HIGH PINES PATIO HOMES PHASE 2E

HIGH PINES PATIO HOMES
PHASE 2E - FINAL PLAT

Project No.: 21053

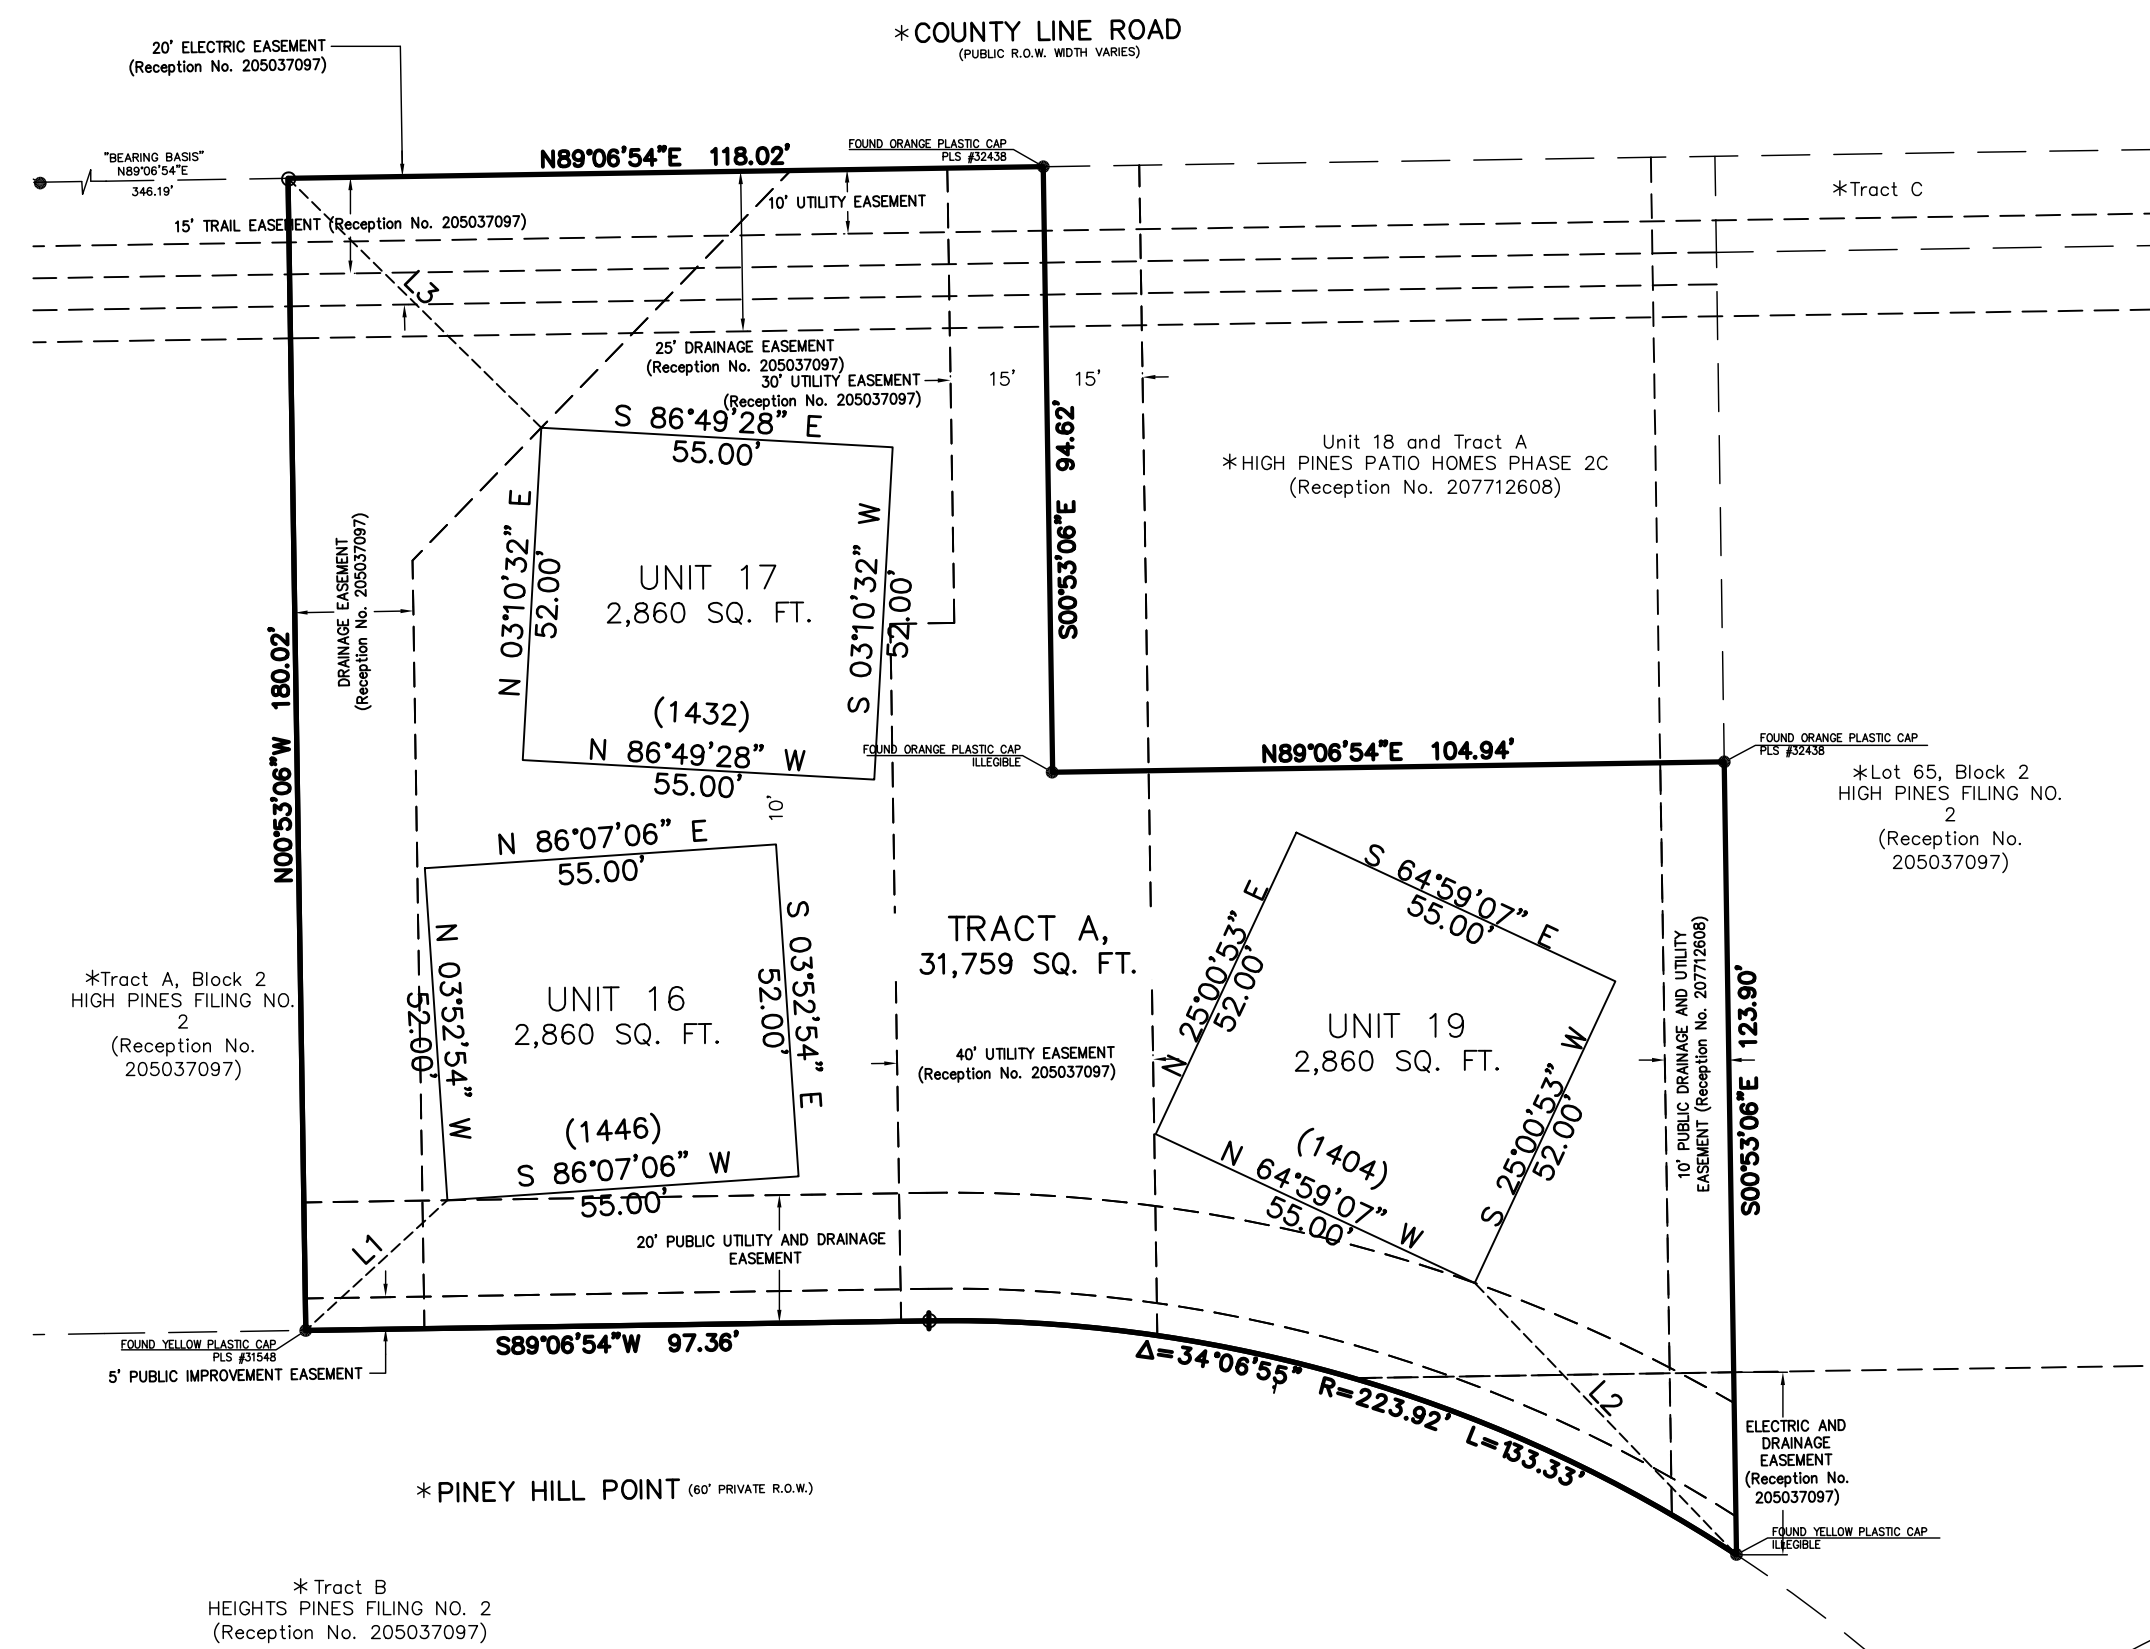
Add the following note to the plat:
"The subdivider(s) agrees on behalf of him/herself and any developer or builder successors and assignees that subdivider and/or said successors and assigns shall be required to pay traffic impact fees in accordance with the el paso county road impact fee program resolution (resolution no.19-471), or any amendments thereto, at or prior to the time of building permit submittals. The fee obligation, if not paid at final plat recording, shall be documented on all sales documents and on plat notes to ensure that a title search would find the fee obligation before sale of the property."

"All property owners are responsible for maintaining proper storm water drainage in and through their property. Public drainage easements as specifically noted on the plat shall be maintained by the individual lot owners unless otherwise indicated. Structures, fences, materials or landscaping that could impede the flow of runoff shall not be placed in drainage easements."
